Re: Consumer Electronics Group/
Electronic Industries Association filing
in MM Docket 87-268

Advanced Television Systems
and Their Impact on the
Existing Television Broadcast
Service

COMMENTS OF THE CONSUMER ELECTRONICS GROUP
of the
ELECTRONIC INDUSTRIES ASSOCIATION

Figure 2: "Just Perceptible" Interference, UHF TV IF Beat

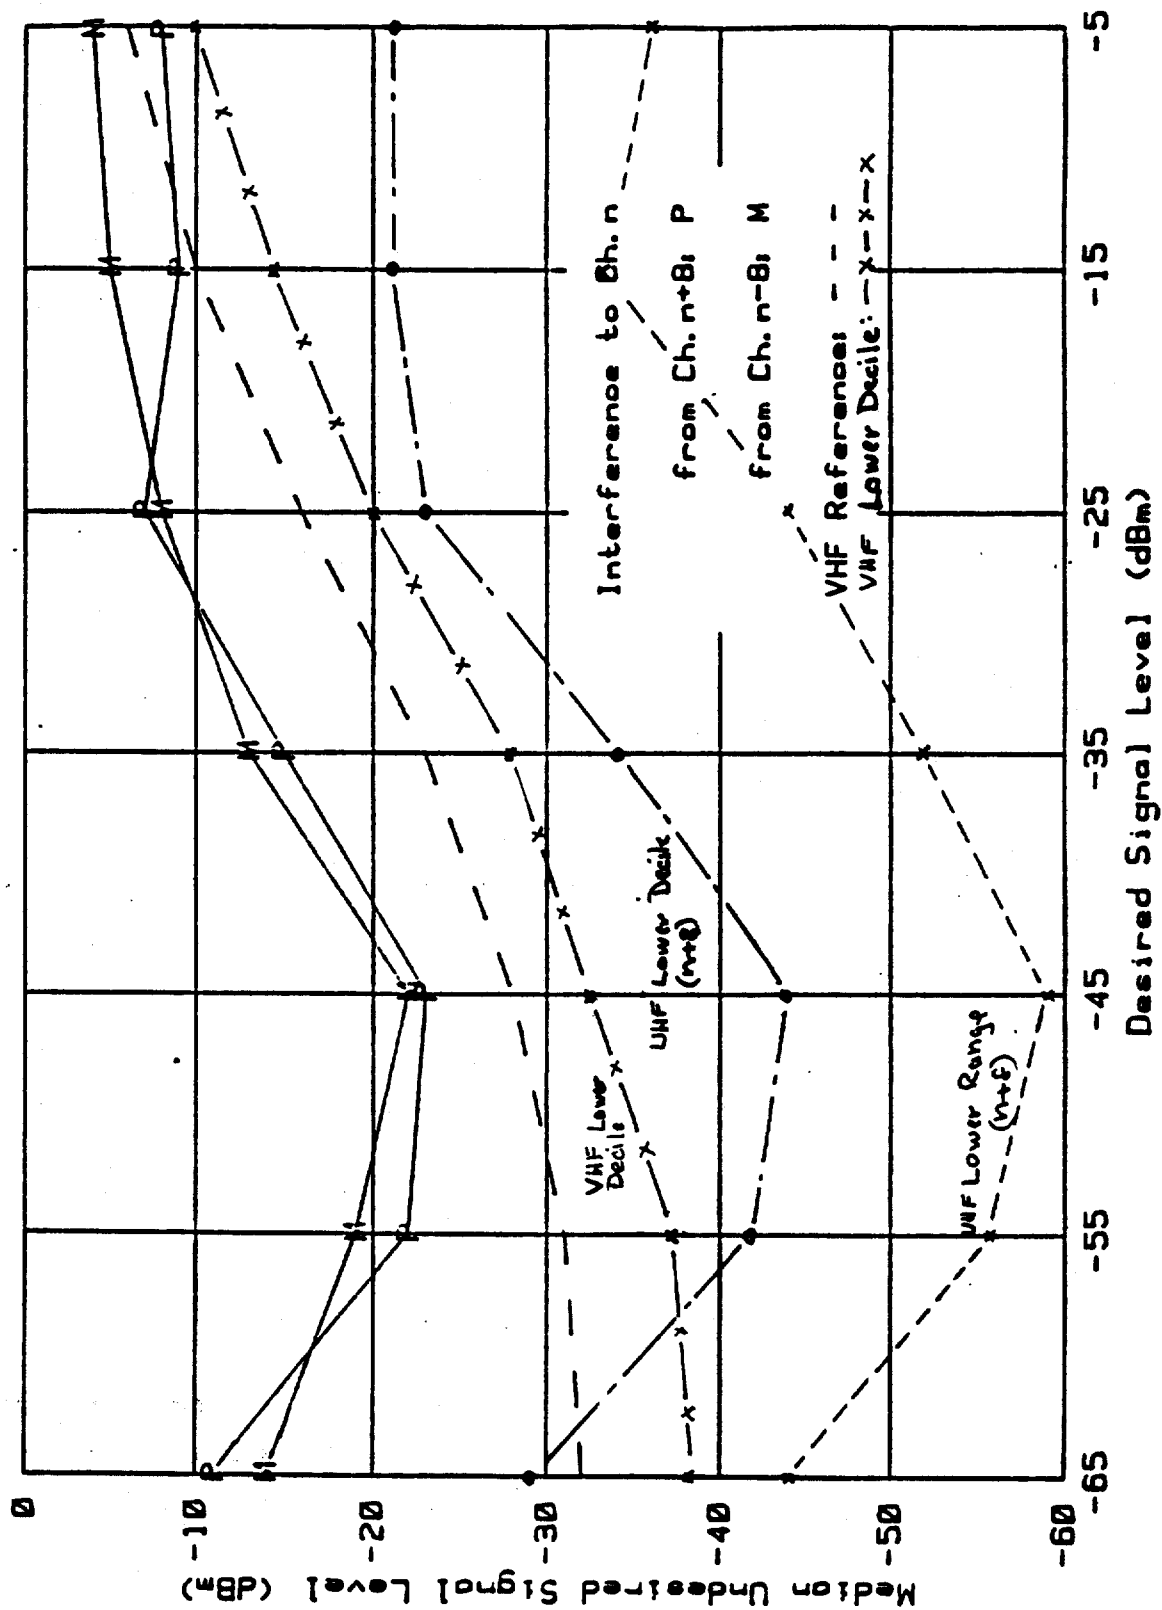
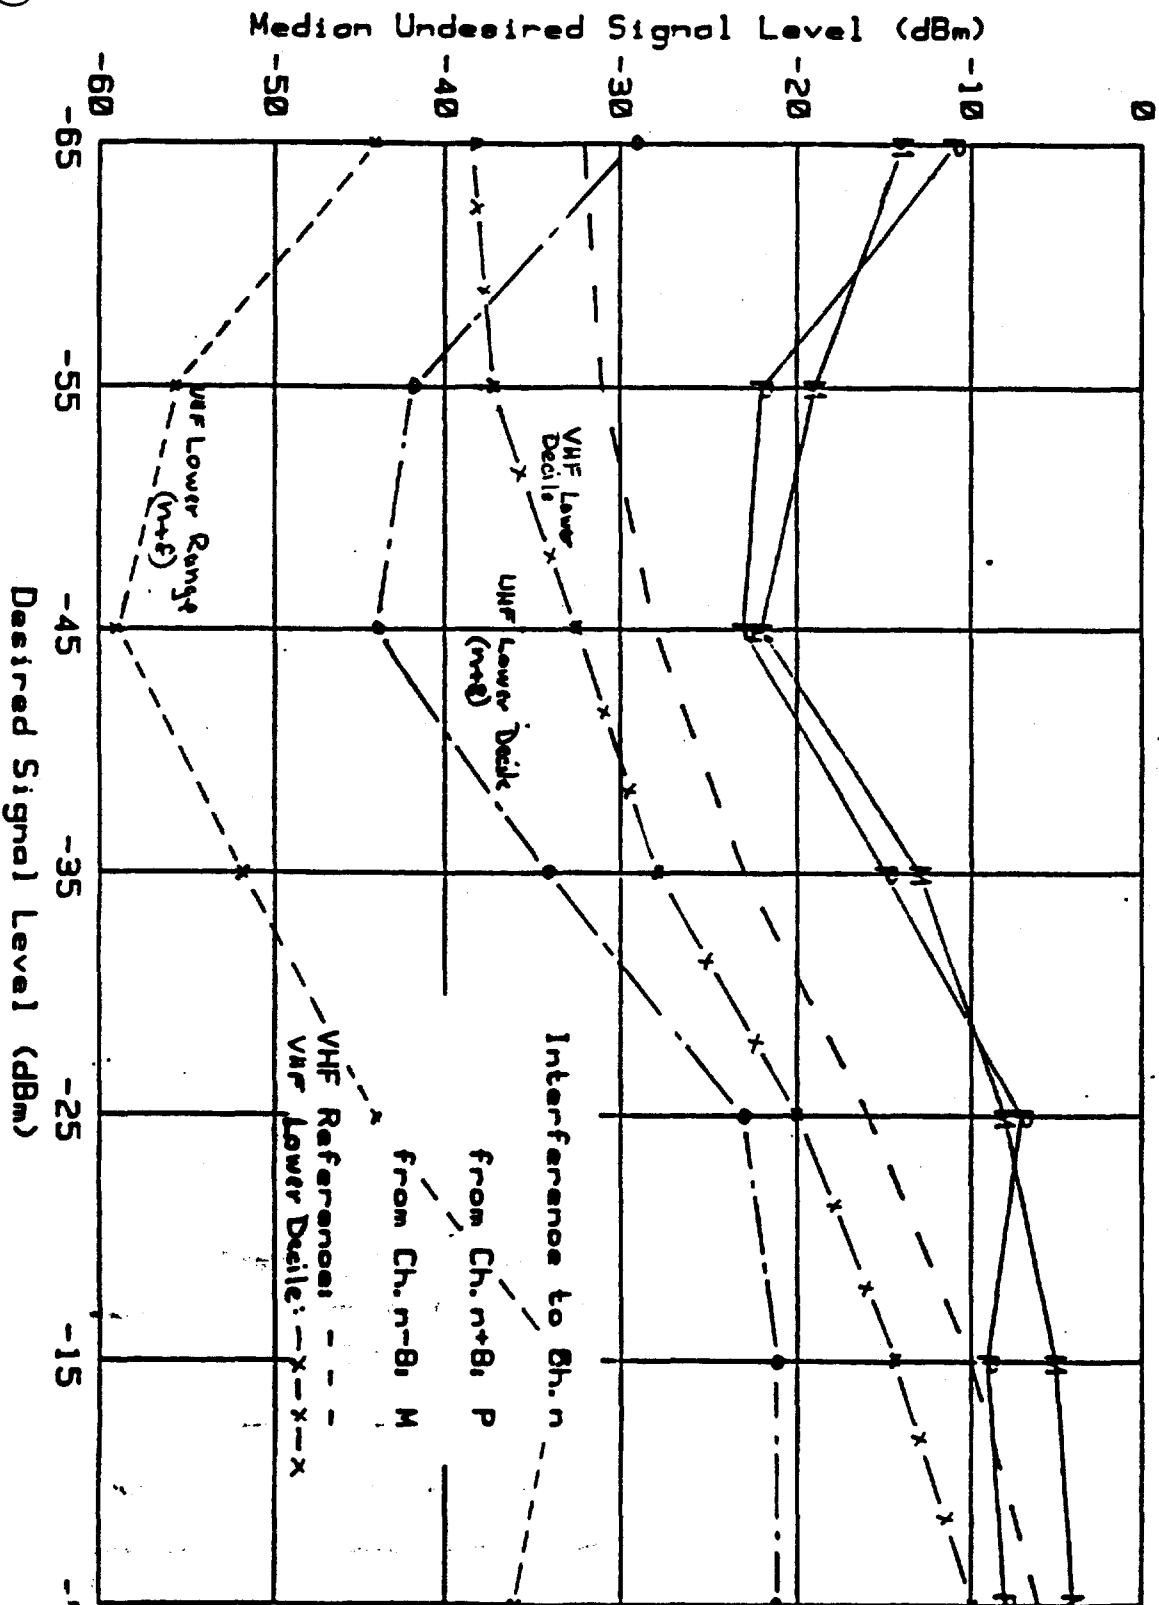
Figure 2 from the memorandum is attached with the VHF and UHF lower decile and UHF lower range performance added. It illustrates that a change in this taboo is not justified. The UHF lower decile performance is not as good as the VHF lower decile performance.
